**Eugene School District 4J
ROOSEVELT MIDDLE SCHOOL**
680 East 24th Avenue
Eugene, OR 97405
CIP No. 410.566.001

ADDENDUM NO. 6

This Addendum forms a part of the Contract Documents and modifies the original Bidding Documents dated February 18, 2015 and subsequent addenda as noted below. Acknowledge receipt of this Addendum in the space provided on the Bid Form. Failure to do so may subject the Bidder to disqualification.

E-101

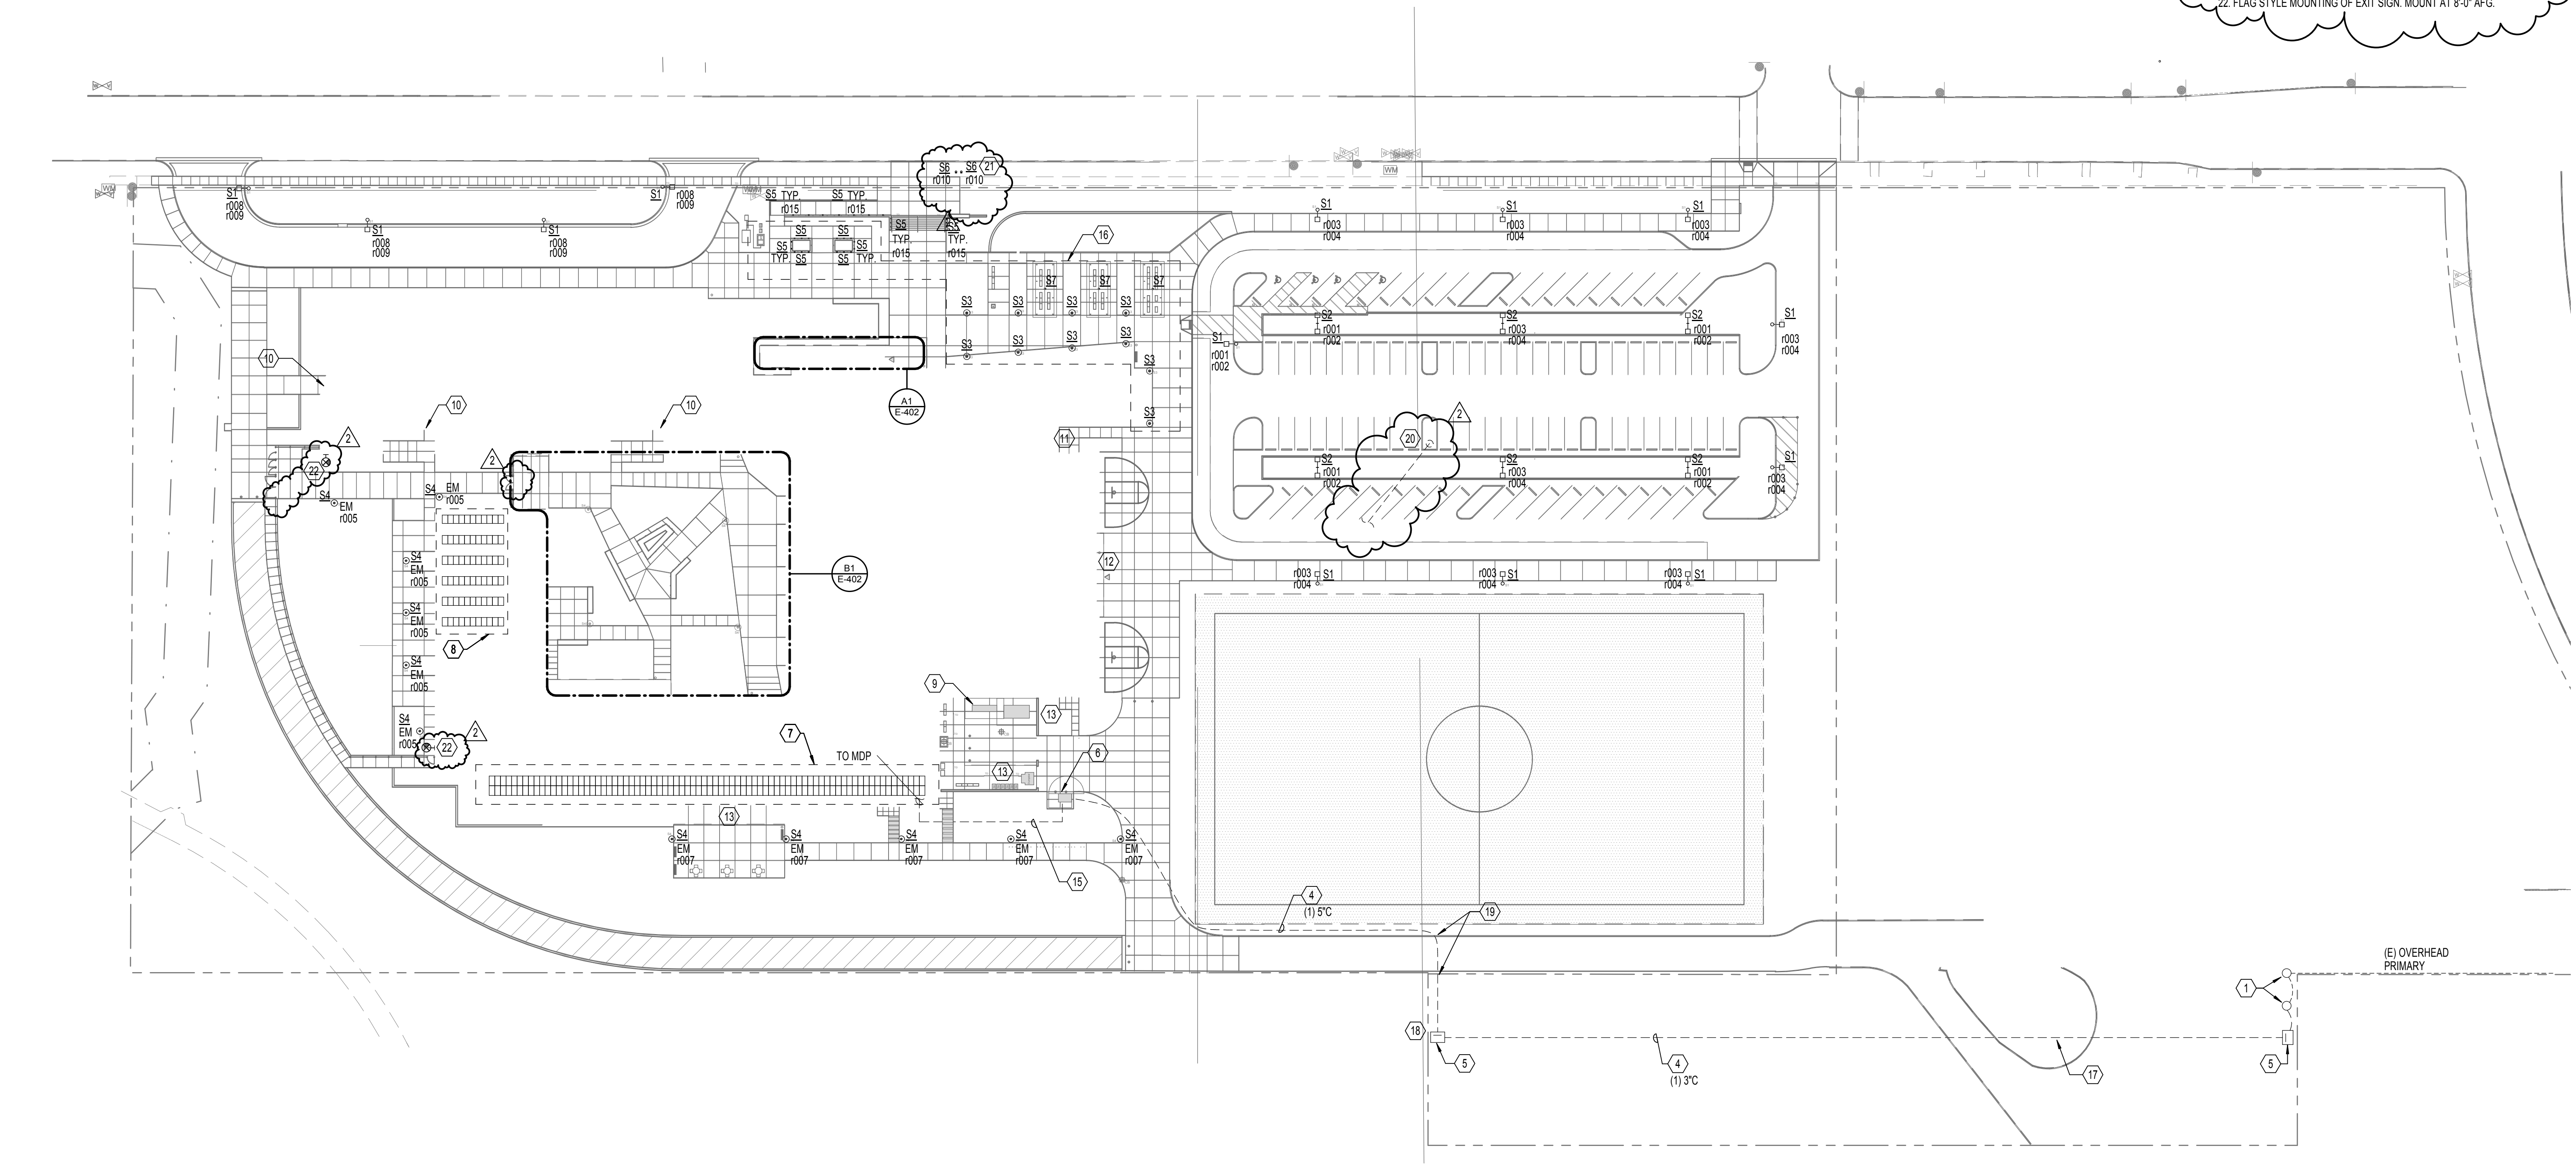
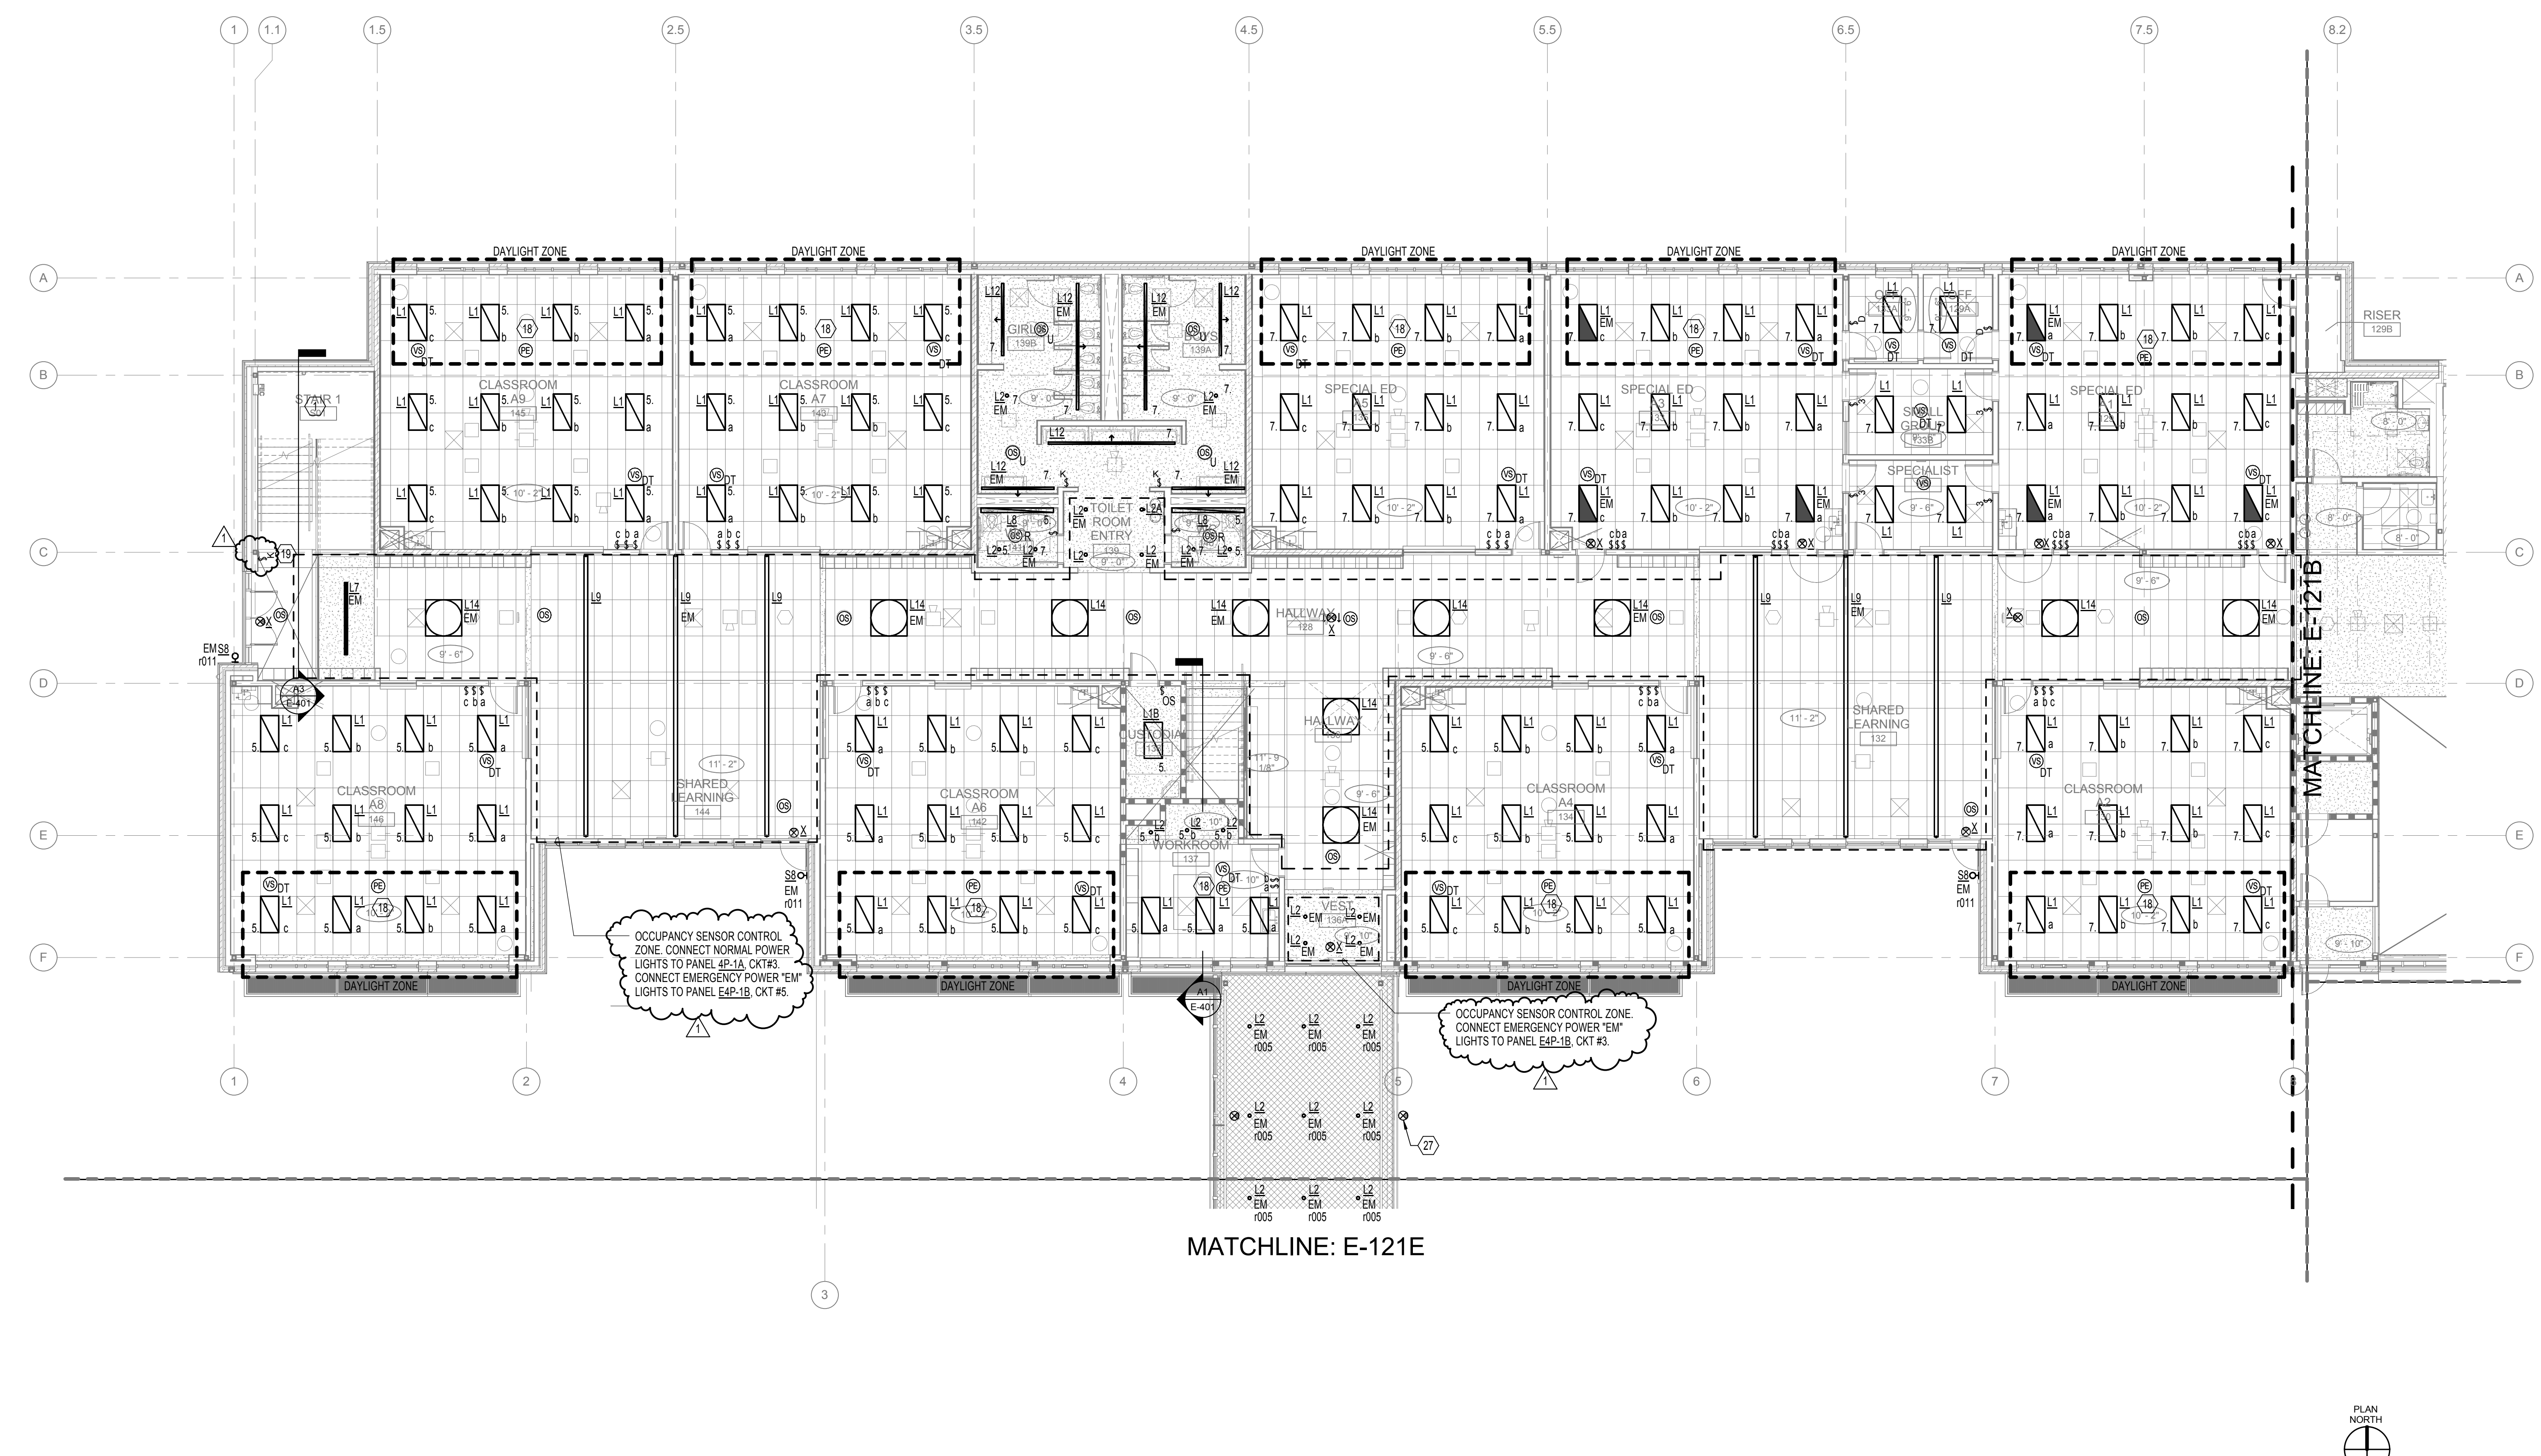
- A. Replace Sheet with revised Sheet E-002: Revise luminaire types.
116. SHEET E-101 SITE PLAN – ELECTRICAL
- A. Replace Sheet with revised Sheet E-101: Relocate exit signs in gated plaza. Relocate luminaires, type S6 as shown. Add Keyed notes 20 and 21. Add spare conduit for future car charger power.

E-121B

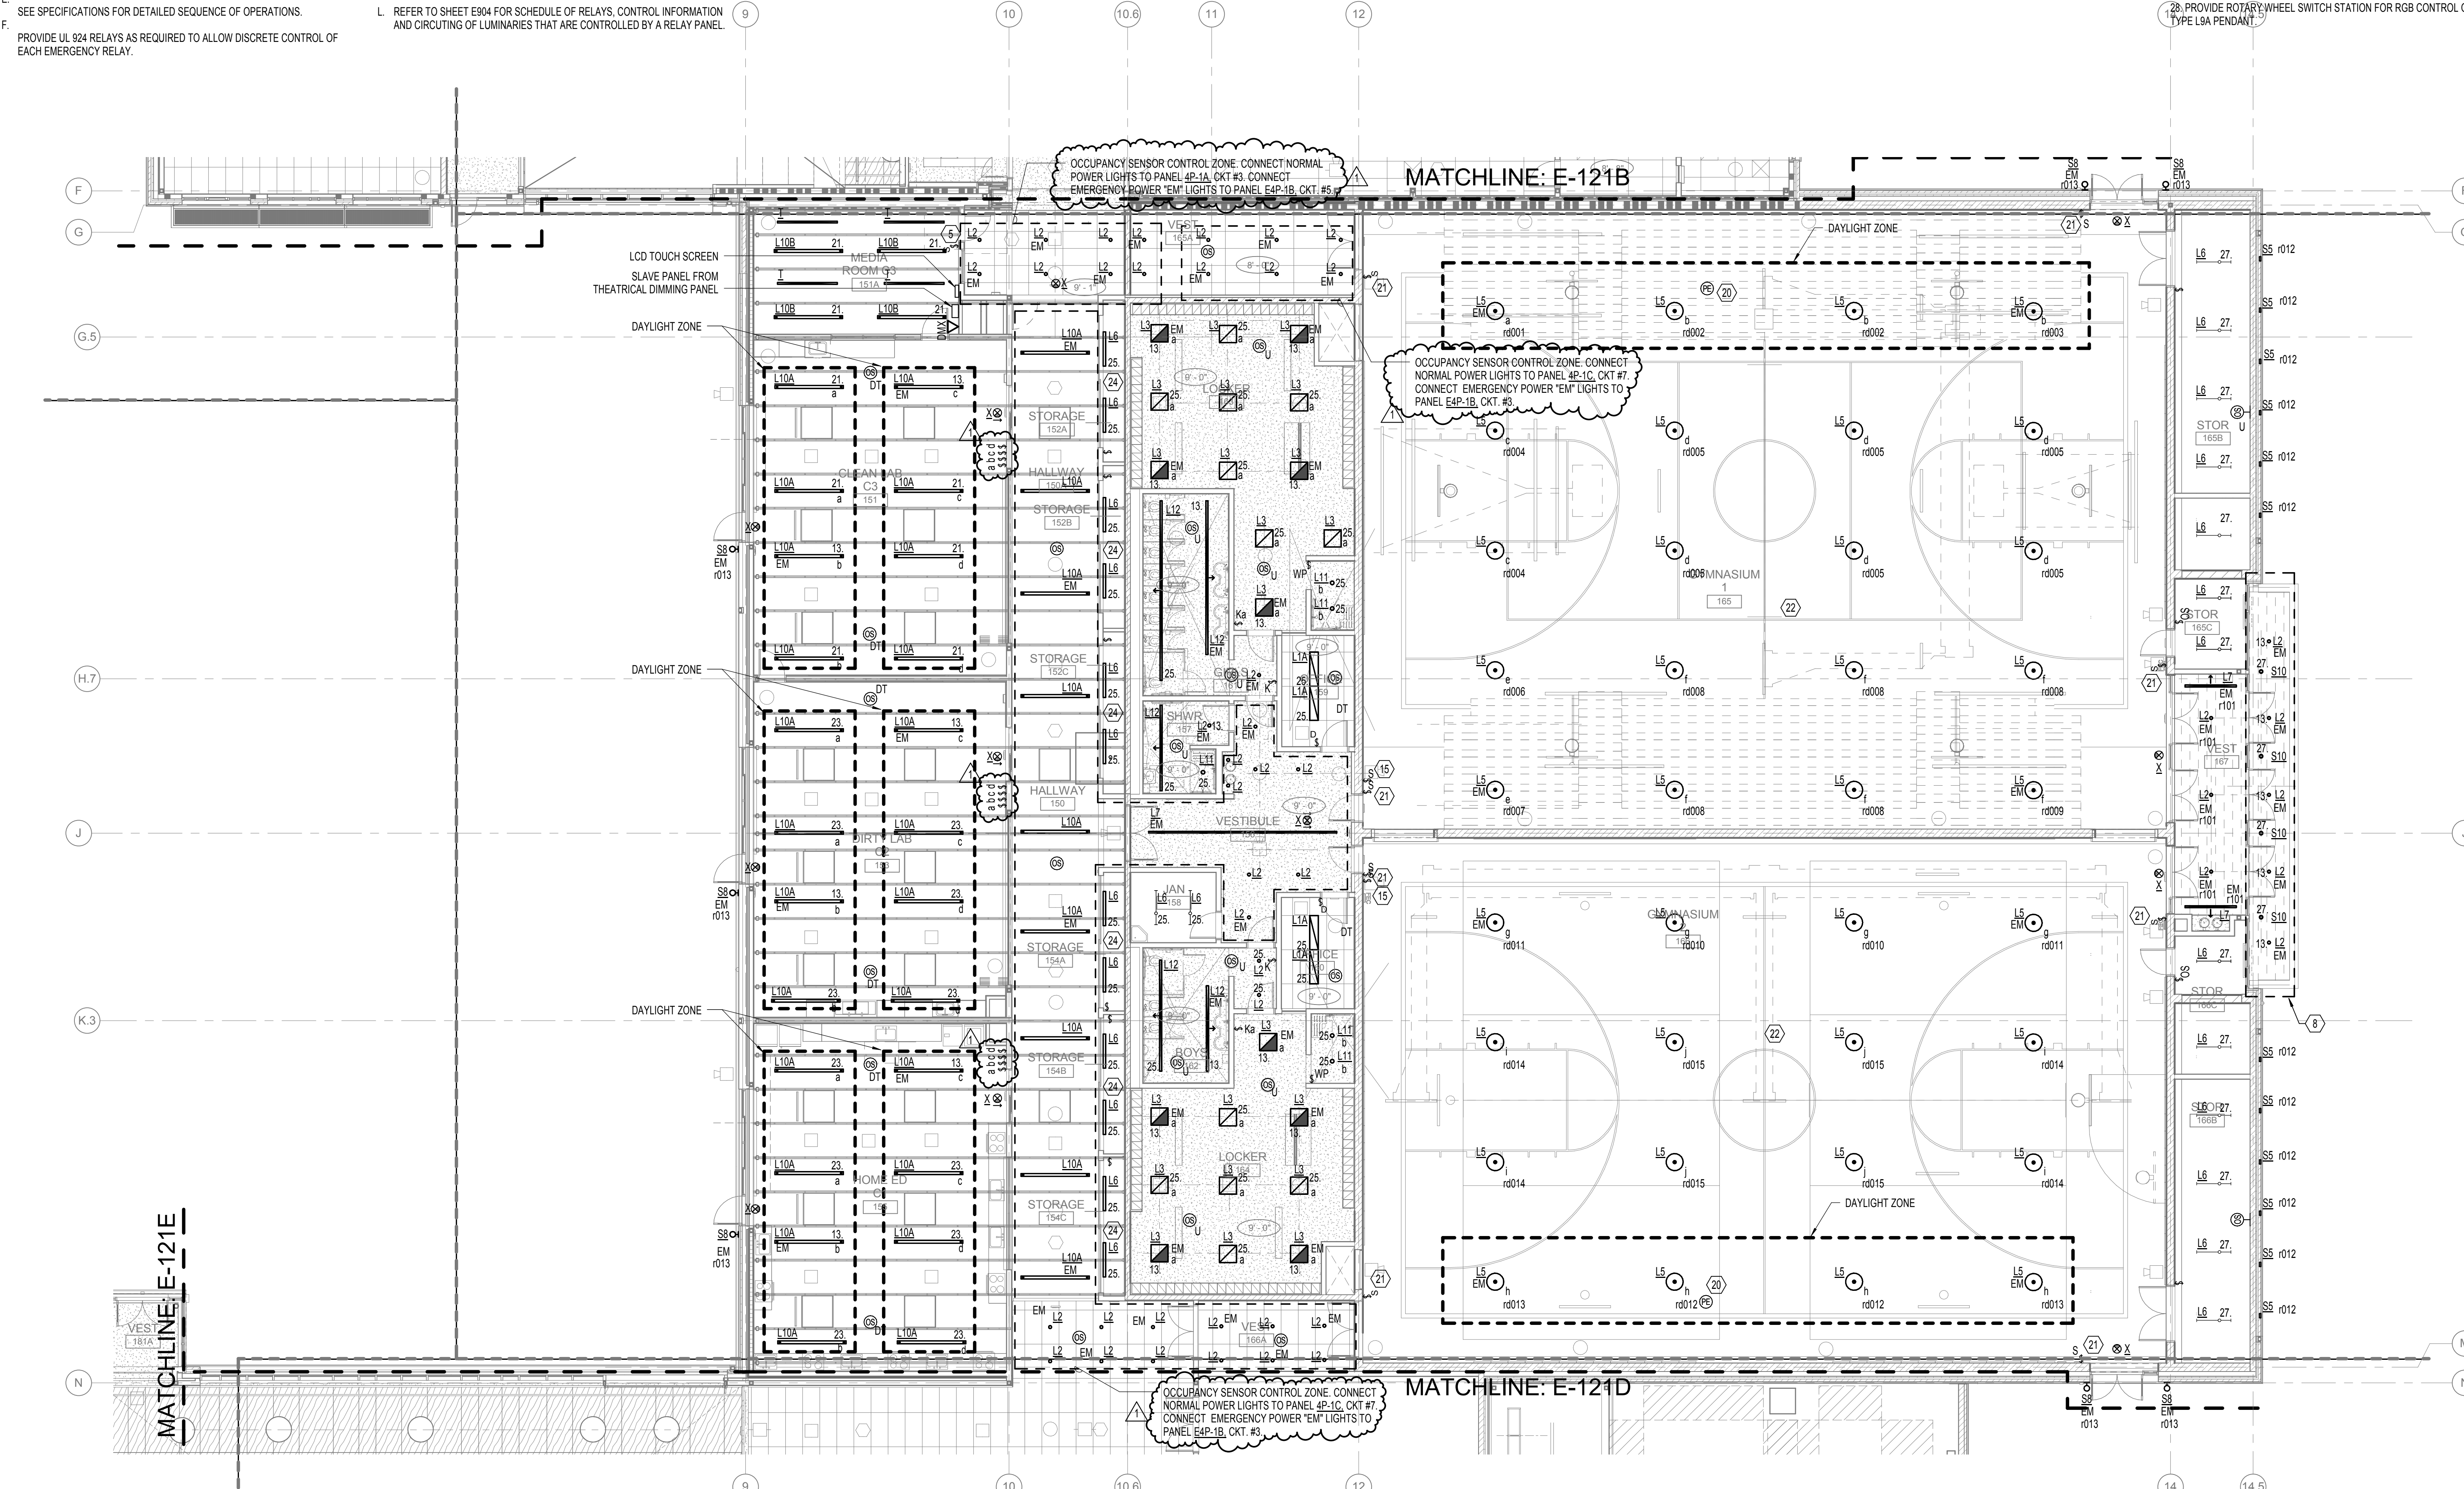
- A. Replace Sheet with revised Sheet E-121B: Remove relays for interior lighting loads tied to the DDC. Circuitry indicated. Provide UL 924 shunt relay for egress lighting in these locations as shown.
